FINAL ALTERNATIVE URBAN AREAWIDE REVIEW (AUAR)

OCTOBER 2019

Final Alternative Urban Areawide Review

Ford Site

Figure 7: Parks and Trails

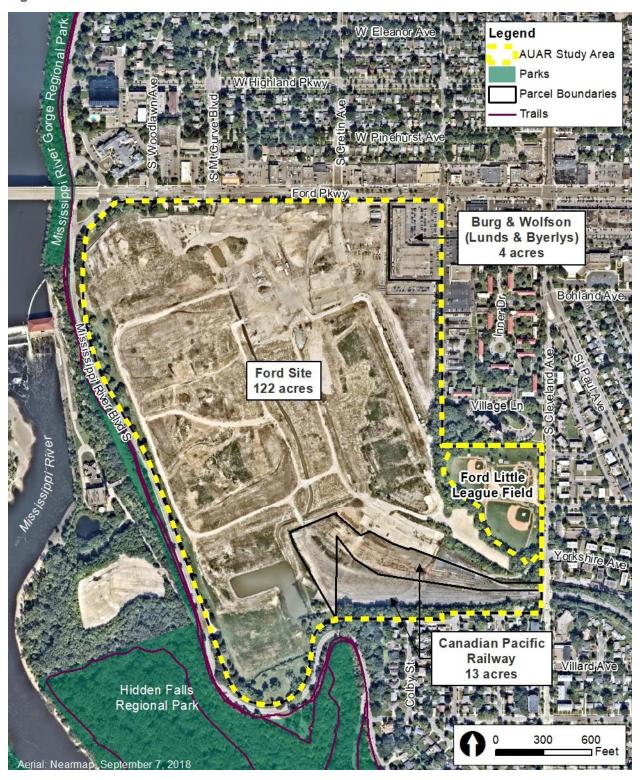
Beyond these specific comments about the regional park and Hidden Falls Creek, Council staff appreciate the preparer's acknowledgement of these Regional Park System components and trail opportunities in the narrative on page 13 and in Figure 7 on page 15 of the AUAR. Further, Council staff appreciate the preparer's indication that parks and trails included in the Ryan Development Scenario will make connections into the City and regional trail network (page 22).

Comment	Response
System components and trail opportunities in the narrative on page 13 and in Figure 7 on page 15 of the AUAR. Further, Council staff appreciate the preparer's indication that parks and trails included in the Ryan Development Scenario will make connections into the City and regional trail network (page 22).	
Geology, Soils, and Topography/Land Forms	
Although identified in the scoping EAW response to the City (Council letter July 9, 2019), the AUAR does not acknowledge the potential groundwater hazards due to karst or to known excavations (example: tunneling beneath the site) in the study area. The AUAR also still concludes that, based on the Ramsey County Geologic Atlas, there are no known sinkholes, unconfined/shallow aquifers, or karst conditions within the AUAR study area. While the 1990 Ramsey County Geologic Atlas does not identify those features, the risk of karst is identified at the site in the 2017 DNR report 'Minnesota Regions Prone to Surface Karst Feature Development', which was developed "for planning, environmental and risk management, hazard mitigation, scientific, and other purposes." That report is online at http://files.dnr.state.mn.us/waters/groundwater_section/mapping/gw/gw01_report.pdf . The report includes links to download the supporting data. The mitigation plan for geology, soils, and topography/land forms (page 62 of the AUAR submitted on August 16, 2019, Review #22290-2) still does not acknowledge karst or excavation risks (such as tunneling beneath the site) as potential impacts or propose mitigation.	Seven documented tunnel systems were constructed in the subsurface below the former Ford Assembly Plant at various depths and configurations. The majority of tunnels are less than 10 feet in width/height, although larger tunnels were documented for the sand mining. Based on information provided by Ford Motor Company, the shallow oil tunnel was completely removed and backfilled. Additionally, the steam tunnel was demolished and removed down to the bottom slab of the tunnel. The bottom slab of the steam tunnel was punctured to provide drainage, and the tunnel area was backfilled with Class 5 fill material. The remaining tunnels were bulk-headed at the entrances and left in existing condition. The southwest end (entrance) to the sand tunnel was noted to be collapsed; however, it was also noted that the collapse was likely intentional. The tunnels do not extend under the surrounding residential areas.

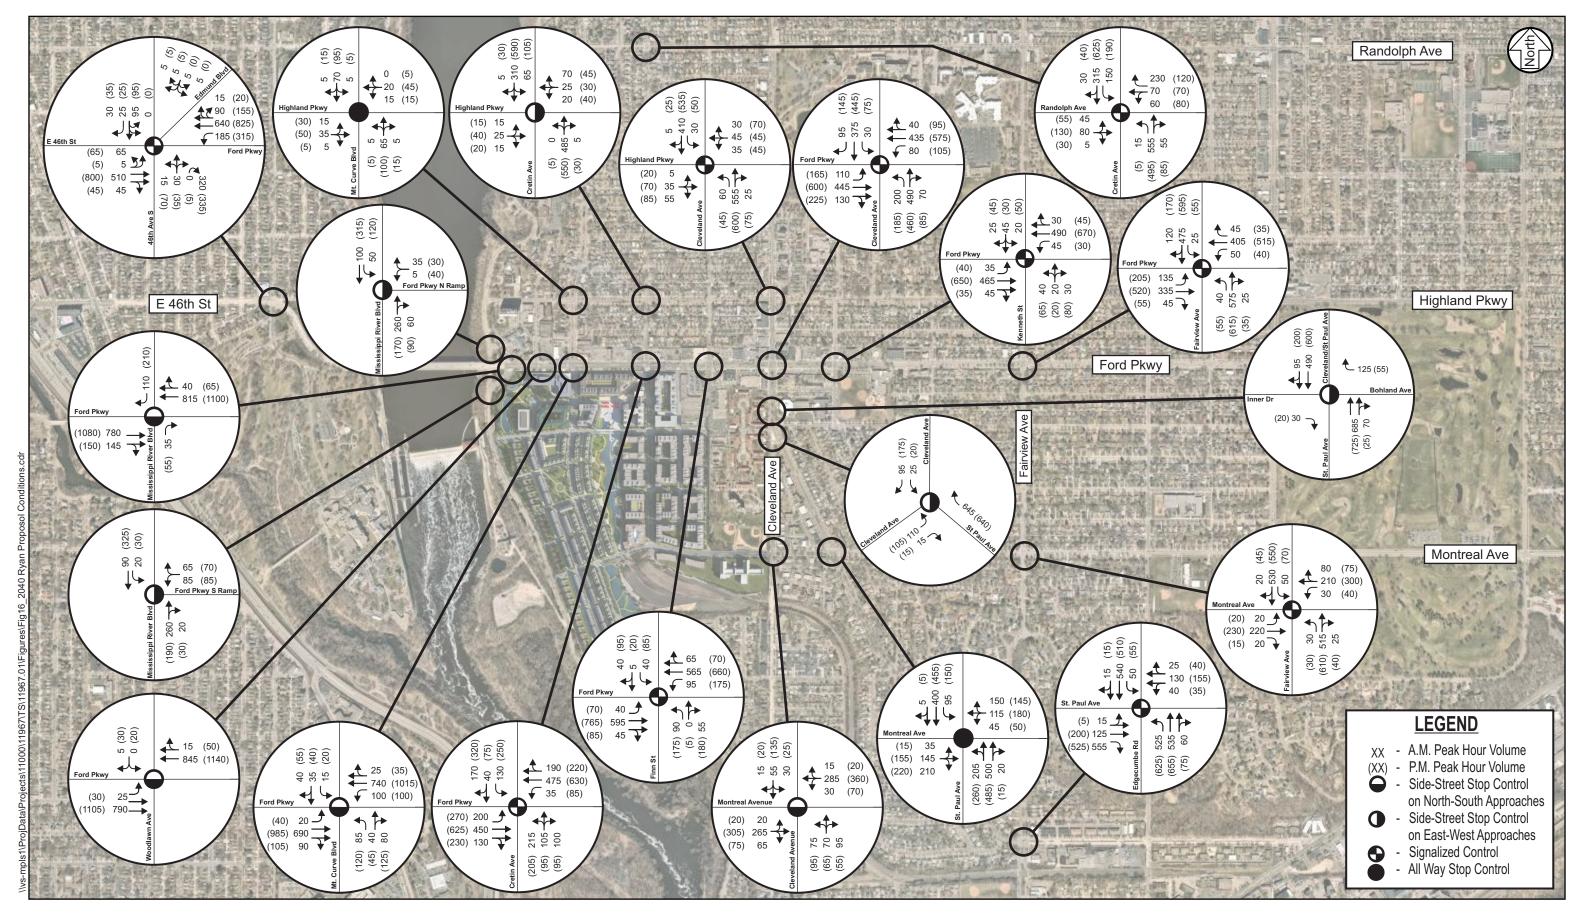
The Directional Distribution information presented on Page 30 and Figure 14 of the Transportation Analysis should be revised to better explain the method for estimating the distribution of auto trips among regional state and county roads (MN 5, MN 51, MN 55, and CSAH 46). It is not clear on Figure 14 what the percentages shown in the large blue ovals, smaller red and blue circles represent.

Comment	Response
Trip Directional Distribution	
The Directional Distribution information presented on Page 30 and Figure 14 of the Transportation Analysis should be revised to better explain the method for estimating the distribution of auto trips among regional state and county roads (MN 5, MN 51, MN 55, and CSAH 46). It is not clear on Figure 14 what the percentages shown in the large blue ovals, smaller red and blue circles represent.	Figure 14 in the Transportation Analysis Report has been updated to clarify (see Appendix D of the Final AUAR).
Multimodal Planning	
The AUAR should provide graphics and narrative describing proposed connections of the site's sidewalks and trails to the Regional Bicycle Transportation Network, which is maintained by the Metropolitan Council.	Discussion of the Regional Bicycle Transportation Network has been added to the Transportation Analysis Report (see page 8 in Appendix D) and Item 18 of the Final AUAR (see page 52). Saint Paul bicycle facilities are shown in Figure 15 of the Final AUAR (page 52).
